Town of Brookline

Walnut Street
Traffic Calming Evaluation

October 2003

BETA Group, Inc.
Engineers • Scientists • Planners
315 Norwood Park South, Norwood, MA 02062 781.255.1982
email: beta@beta-inc.com

Figure No. 2
Neckdown @ Upland Road

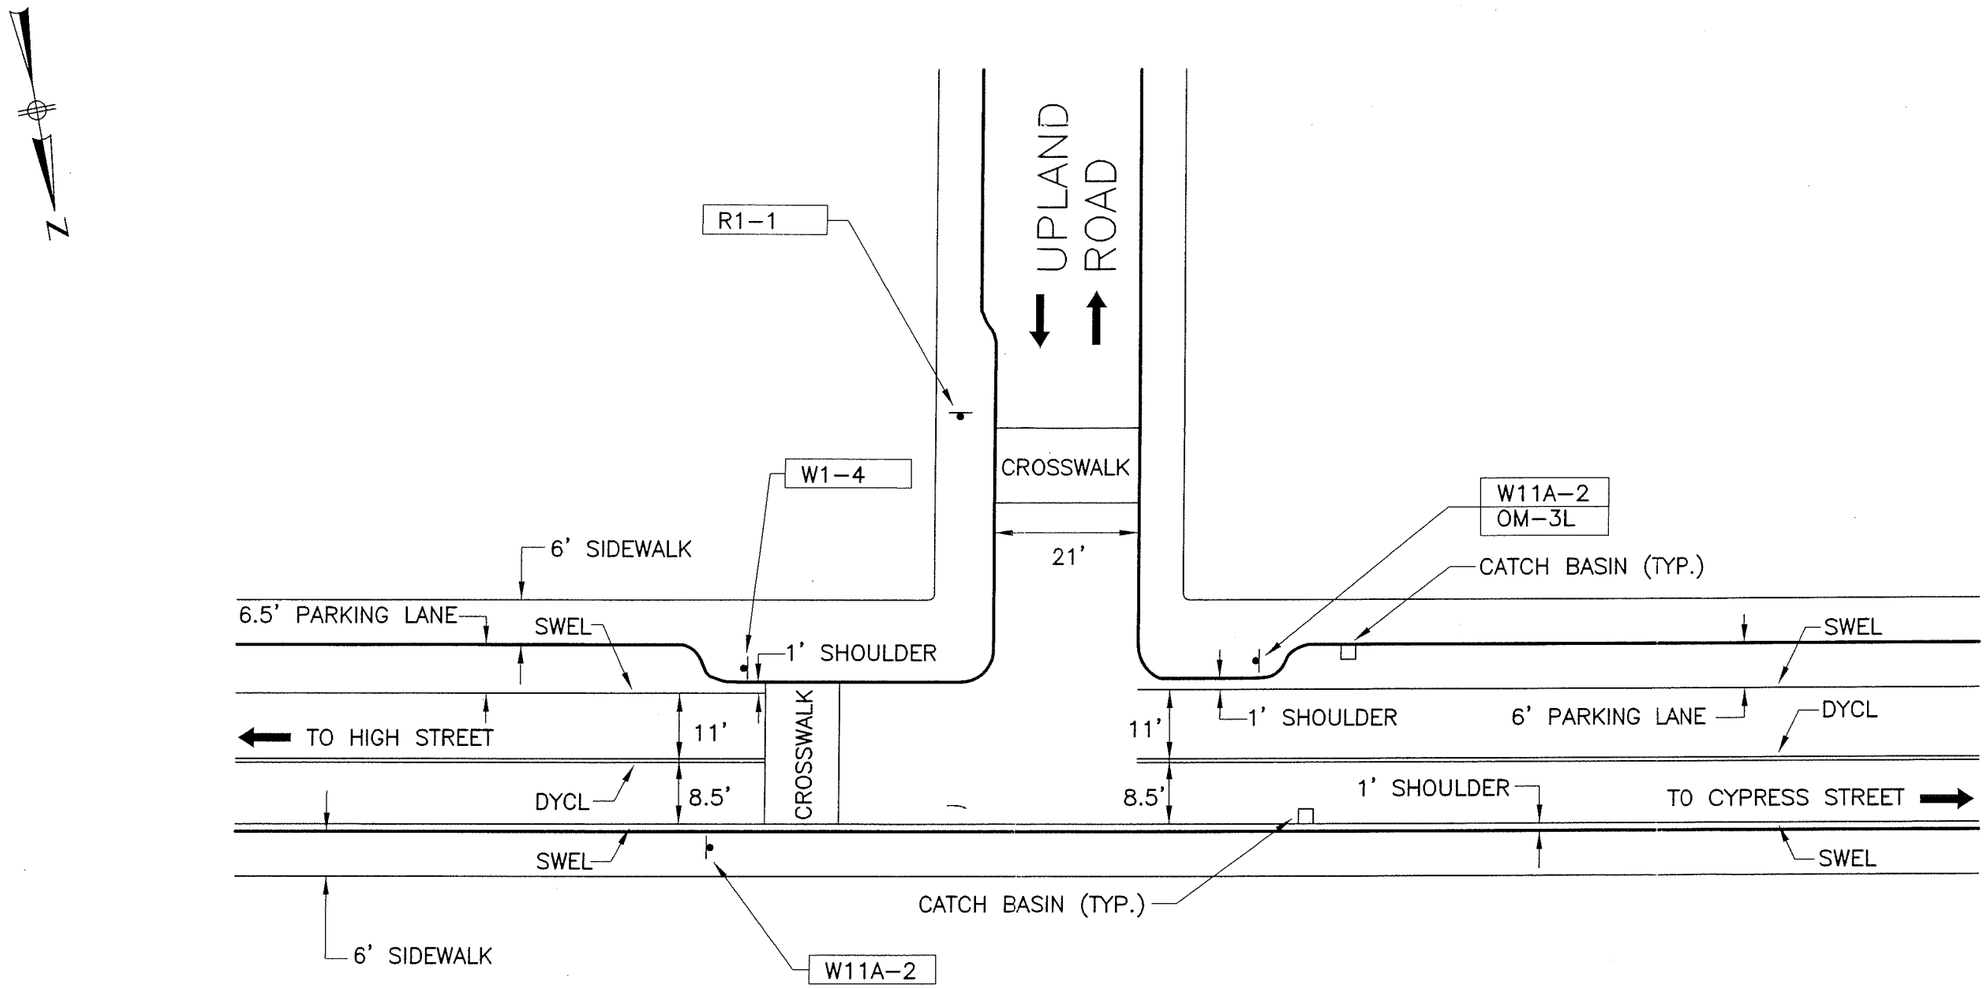
The Upland Road neckdowns narrow the Walnut Street travel lane to 8.5 feet and 11 feet for the westbound and eastbound travel directions, respectively. A one-foot shoulder is also provided for both travel directions. The westbound 8.5-foot travel lane does not meet the Massachusetts Highway Design Standard and AASHTO minimum roadway width (10-foot) for a collector street. The sub-standard lane width (8.5 feet) is unsafe from an operational standpoint.

- The westbound roadway width (8.5') and parking lane width (6.0') do not meet AASHTO and MassHighway design standards which call for a minimum of 10'travel lanes and 7' parking lane for collector roads.
- The crosswalks on the Upland Road and Walnut Street approach are located too far away from the intersection, approximately 15 feet south and east of the intersection respectively.
- The turning radius for vehicles turning in and out of Upland Road from Walnut Street is tight due to the neckdown curb extension.
- There are no catch basins provided at the eastern side of the neckdown curb extension.

- Restrip travel lane width and parking lane to provide a 7 foot parking lane and 10 foot travel lane to conform with AASHTO and MassHighway design standards for parking and lane widths for collector roads.
- Consider relocating the crosswalks closer to the intersection.
- Consider improving the curb extension radius at the intersection to allow adequate vehicle turning radius from Upland Road onto walnut Street.
- Install catch basins east of the neckdown curb extension to prevent ponding of water at the curb extension.

Figure No. 3
Neckdown @ Irving Road

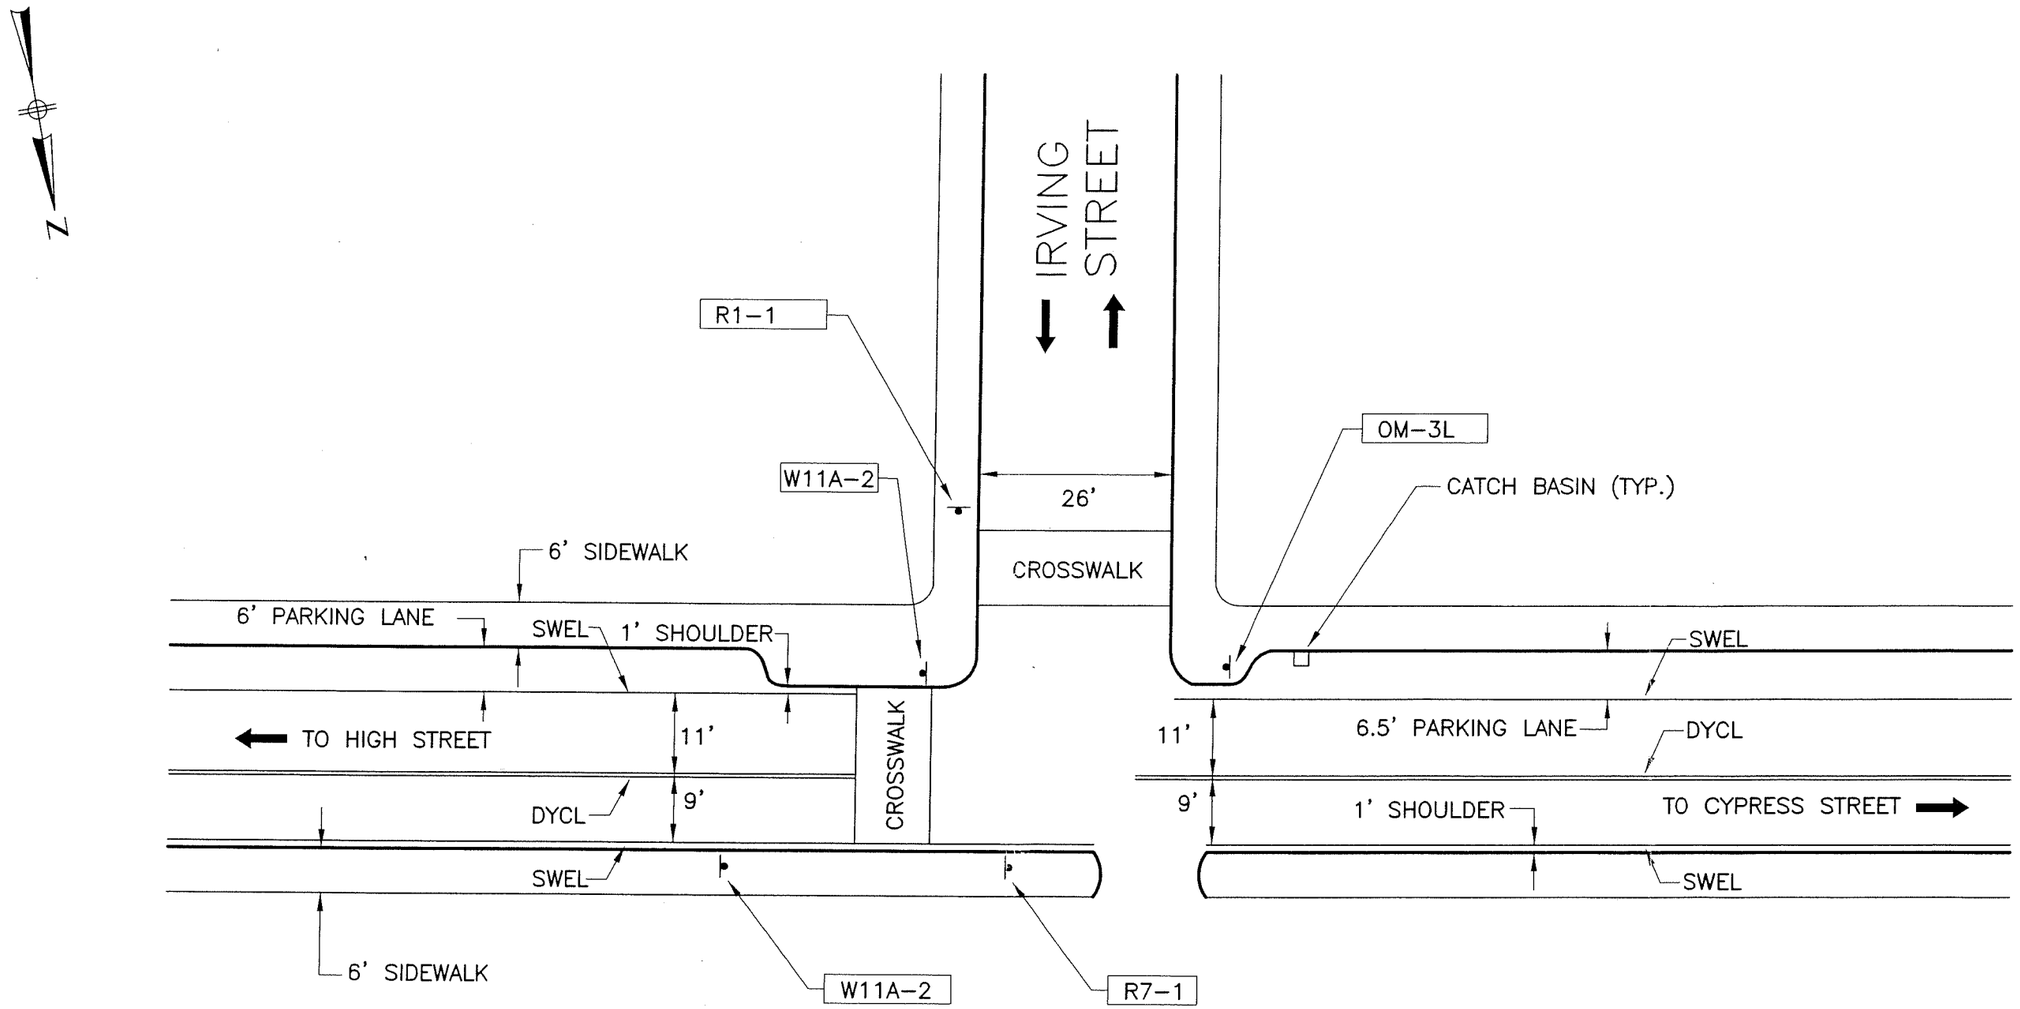
The neckdown at the southeast corner of the Irving Street intersection, as shown in Figure 3, is approximately five feet wide and thirty-one feet long while the southwest corner is approximately fourteen feet long and 4.5 feet wide. The neckdowns narrow the Walnut Street travel lane to approximately 9 feet and 11 feet for the westbound and eastbound travel directions, respectively. A one-foot shoulder is provided for westbound travel direction. The westbound 9-foot travel lane does not meet the Massachusetts Highway Design Standard and AASHTO minimum roadway width (10-foot) for a collector street. The sub-standard 9-foot travel lane is unsafe from an operational standpoint.

- The westbound roadway width (9') and parking lane width (6.0') do not meet AASHTO and MassHighway design standards.
- Vehicles are parked too close to the southwest corner of the intersection restricting sight lines at the Irving Road approach.
- The turning radius for vehicles turning in and out of Irving Road from Walnut Street is tight due to the neckdown curb extension.
- There are no catch basins east of Irving Road.

- Restrip travel lane and parking lane widths to provide a 7 foot parking lane and 10 foot travel lane to conform with AASHTO and MassHighway design standards for travel lane and parking widths for collector roads.
- Consider improving the curb extension radius at the intersection to improve vehicle turning in and out of Irving Road.
- Restrict parking 20 feet from the curb extension at the southwest corner to improve sight lines for the Irving Road approach.
- Install catch basins east of the neckdown curb extension to prevent ponding of water at the curb extension.

Figure No. 4
Raised Crosswalk
@ Walnut Path

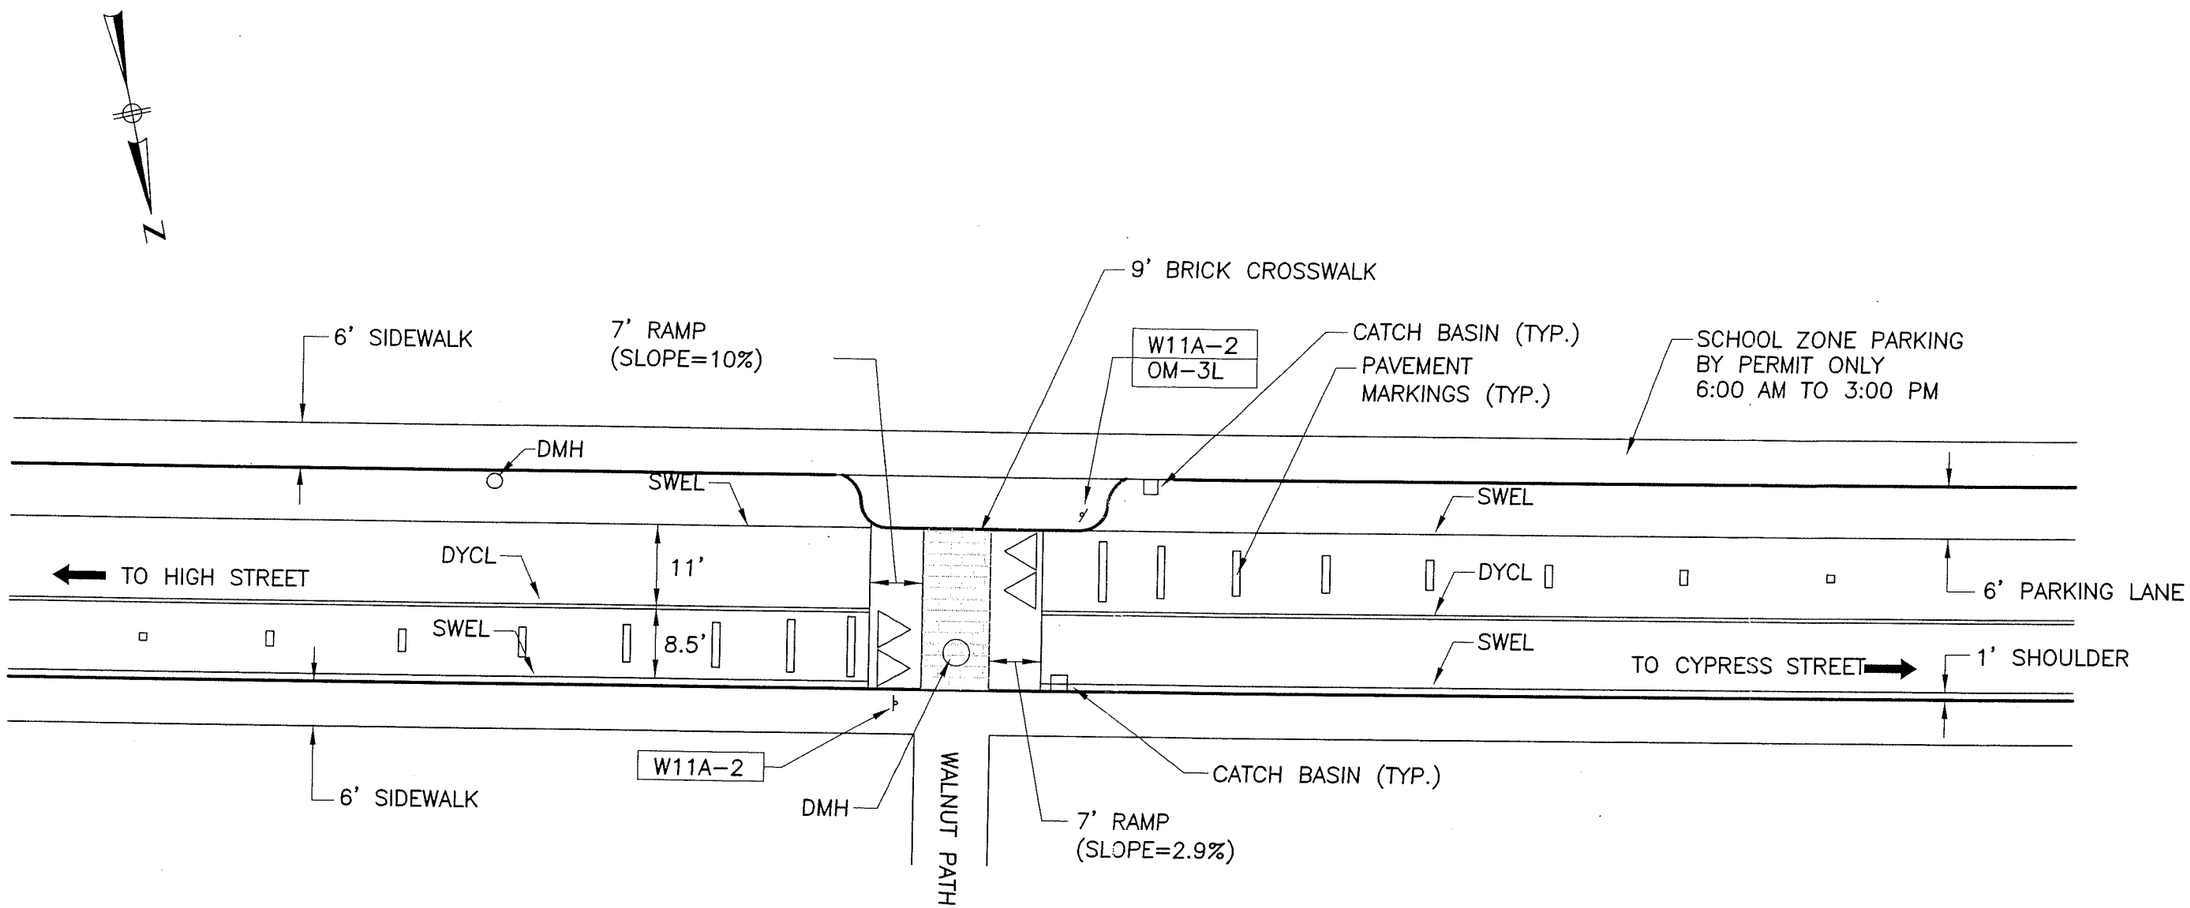
The device shows no signs of deteriorating material such as loose curbs or brick paver joints. The overall design of the device meets the minimum design criteria for a raised crosswalk as outlined in the ITE Traffic Calming State of the Practice with the exception of the ramp slope and the curb extension area which reduces the travel lane width to 8.5 feet. If the goal is to reduce vehicular speed to 20 mph at the raised crosswalk, the 10% and 2.9% slopes do not meet the ITE design standard, which calls for 8% ramp slopes.

The 10% ramp slope exceeded the industry standard for raised crosswalk of 8% ramp slope for a 20 mph travel speed. The 10% slope will create safety problem for vehicle crossing the raised crosswalk and vehicle may air borne and bottom out as they depart from the device. The 2.9% slope will allow vehicles to cross the raised crosswalk at speeds greater than the 20 mph posted advisory speed. In addition, the transition between the existing roadway and the crosswalk ramps

- The raised crosswalk ramp slopes (10% and 2.9%) were not constructed to industry standards for a 20 mph design speed which calls for an 8% slope. The reduced ramp slopes permit vehicles to traverse the raised crosswalks at speeds greater than the posted 20 mph advisory speed. Thus causing vehicles to bottom out as they depart the raised crosswalk and causing pavement damage and potential safety concerns.

- Restrip travel lane and parking lane widths to provide a 7 foot parking lane and 10 foot travel lane to conform with AASHTO and MassHighway design standards for travel lane and parking widths for collector roads.
- Improve raised crosswalk ramp slopes to meet industry standards for a 20 MPH design speed, which calls for an 8% slope.
- Install catch basins east of the raised crosswalk to prevent ponding of water at the ramp at the eastern edge of the crosswalk.
- Replace the existing pedestrian crossing sign (W11A-2) with "Raised Crossing" sign.
- Removed advance signage for raised crosswalk. Also, see signage improvements section.

Figure No. 5
Raised Crosswalk and Chicane @ Oakland Road

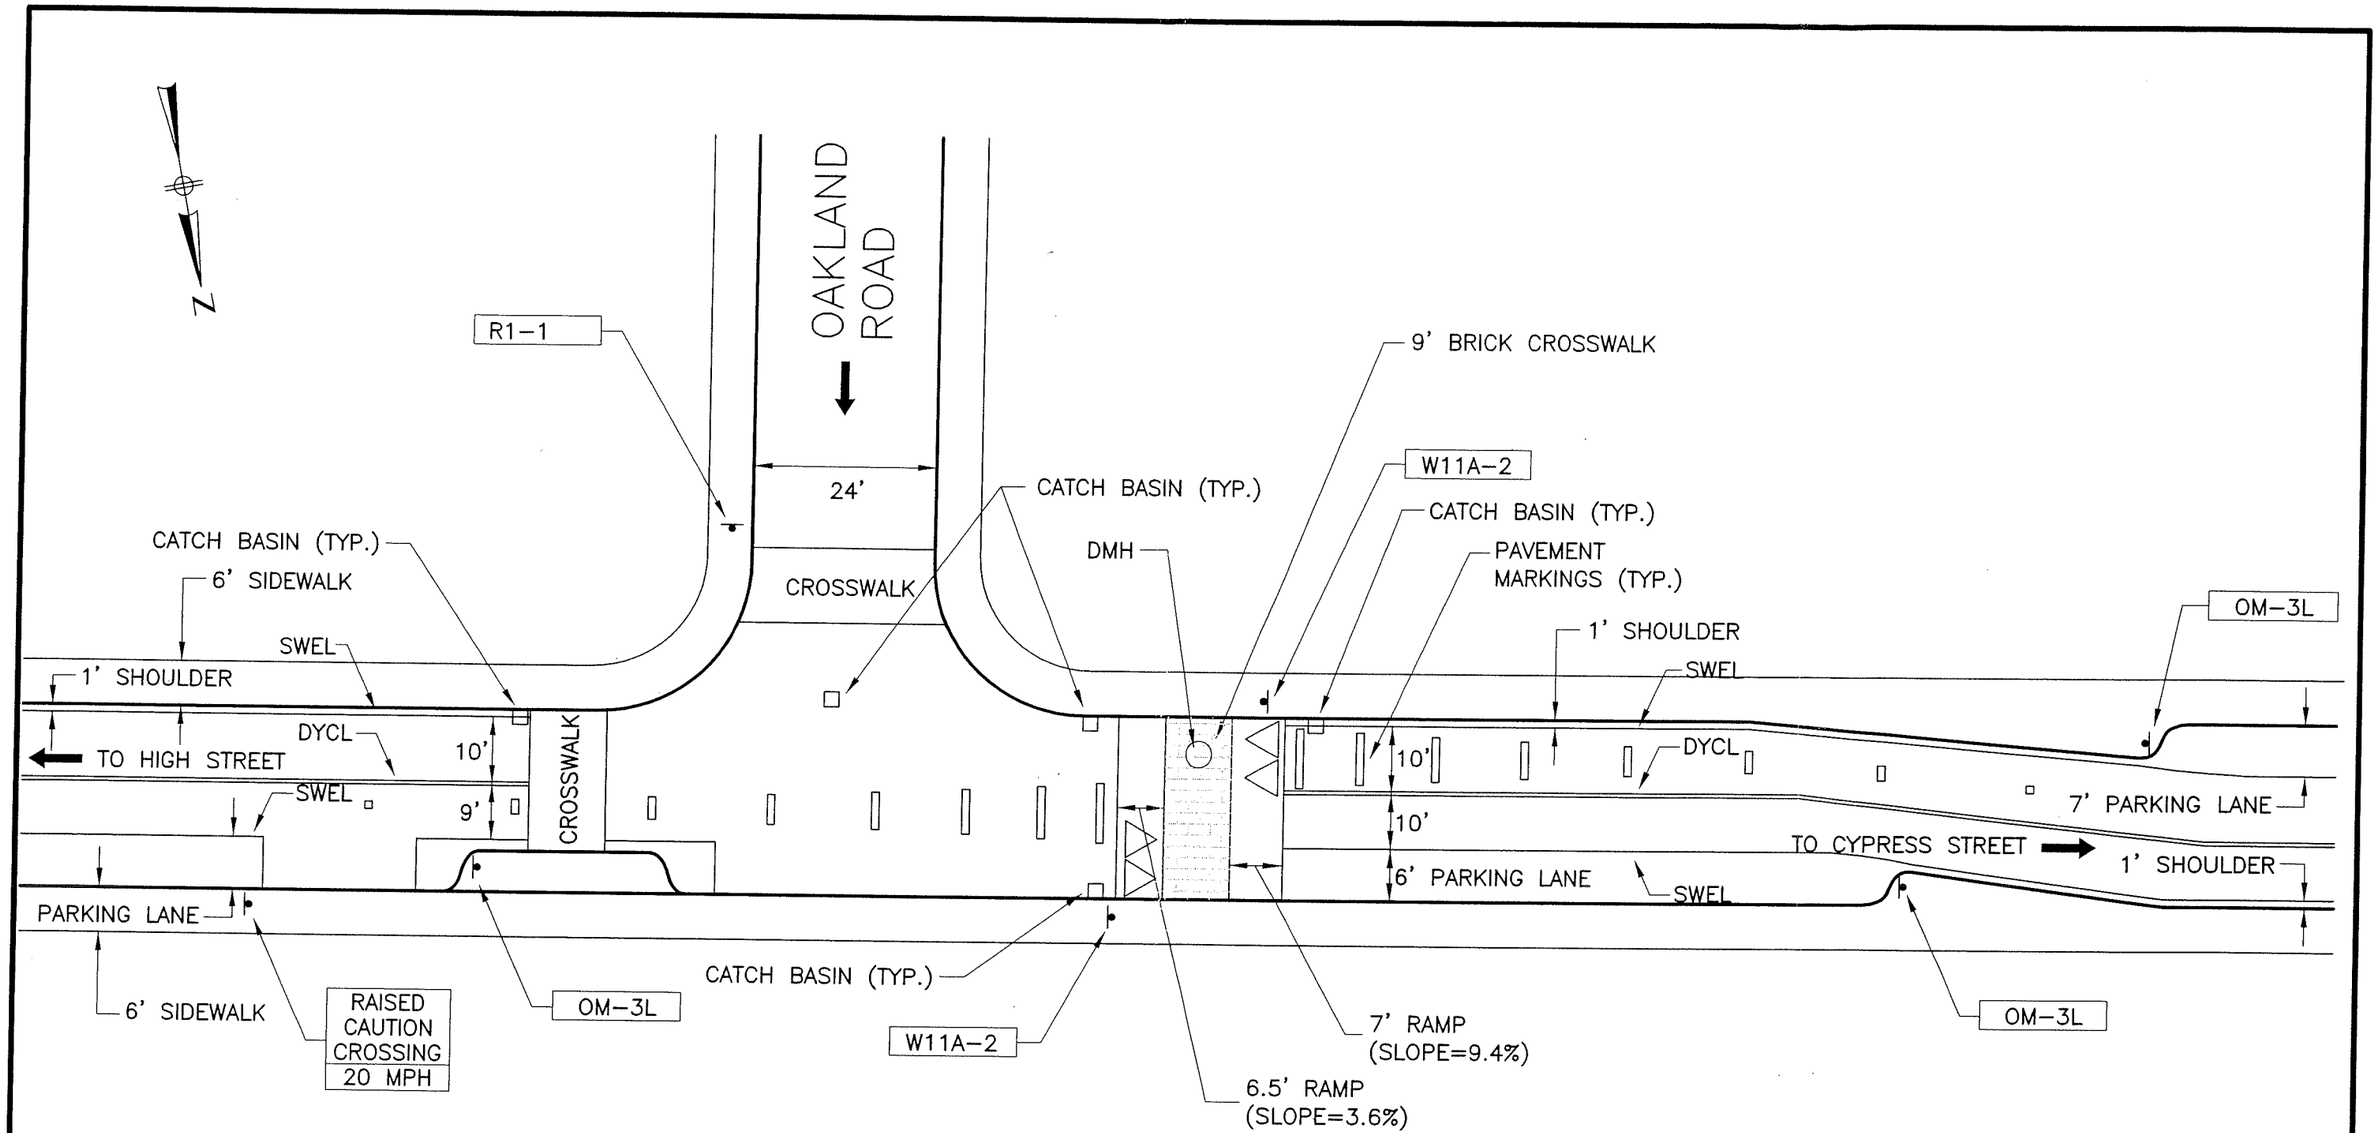
The west side of the ramp slope (9.4%) exceeds the industry standard for raised crosswalk which

is 8% for a 20 mph travel speed. However, the east side of the slope (3.6%) is less than 8%, which allows vehicles to cross the raised crosswalk at speeds greater than the 20 mph posted advisory speed. The substandard slope accounts for the pavement injury that exists in the area departing the raised crosswalk from both the travel directions. The scraped pavement indicates that vehicles are traveling at high speeds exceeding the posted 20 mph advisory speed when crossing the raised crosswalk and bottoming out as they depart from the device. The speeding at the raised crosswalk is also due to the wide spacing between the two raised crosswalks.

- The raised crosswalk ramp slopes (3.6% and 9.4%) were not constructed to industry standards for a 20 mph design speed which calls for an 8% slope. The reduced ramp slopes permit vehicles to traverse the raised crosswalks at speeds greater than the posted 20 mph advisory speed. Thus causing vehicles to bottom out as they depart the raised

- Restrip travel lane and parking lane widths to provide a 7 foot parking lane and 10 foot travel lane to conform with AASHTO and MassHighway design standards for travel lane and parking widths for collector roads.
- Reconstruct raised crosswalk ramp slopes to meet industry standards for a 20 MPH design speed, which calls for an 8% slope.
- Replace the existing pedestrian crossing sign (W11A-2) with "Raised Crossing" sign.
- Removed advance signage for raised crosswalk. Also, see signage improvements section.
